TICK/POP/SNAPPING/BUZZ NOISE FROM DOOR PANEL WHEN OPERATING AUDIO SYSTEM— VEHICLES BUILT BEFORE 5/1/2009

TSB 09-12-7

FORD:
2010 Mustang

Figure 1 - Article 09-12-7

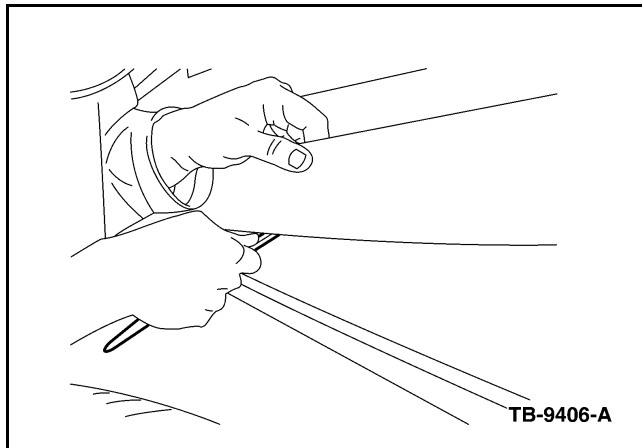
Some 2010 Mustang vehicles built before 5/1/2009 may exhibit a tick/pop/snapping/buzz noise when using the audio system at high volumes, bass levels, or voice broadcasts. A small piece of casting flash on the lower map pocket contacting the door panel is the source of the noise.

1. Obtain a piece of soft PVC foam (164-R4901) from the Rotunda Squeak and Rattle Repair Kit (164-R4900)
2. Cut a 1/2" (12.7 mm) wide strip of soft PVC foam lengthwise.
3. Using a Trim Stick or suitable tool gently push the 1/2" (12.7 mm) wide strip of soft PVC foam between the lower edge of the map pocket and door panel. Center the PVC foam under the door grab handle. (Figure 1)
